Access Compliance Report

Public Rights-of-Way

(Curb Ramps)

Intersection ID: 15786	Main Street: N_SHARON_AMITY_RD	Cross Street: AMITY_PL	Location: S
ADA ID: 8AD49FBAEBB0	Ramp Type: BlendTrans1	Initial Pass/Fail: Pass	Overall Compliance: No
Severity Score: 0.25			
Codes/Mitigation Info/Possible Solution		Field Measurements/Component Compliance

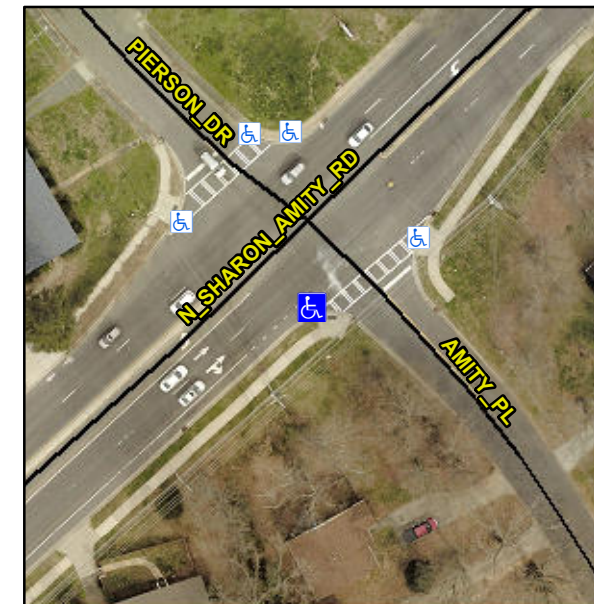
DWS WARPED

R304.5.3, R305.2

Remove & Replace Curb Ramp With Two New Directional Ramps or Equivalent. Remove & Replace Gutter.
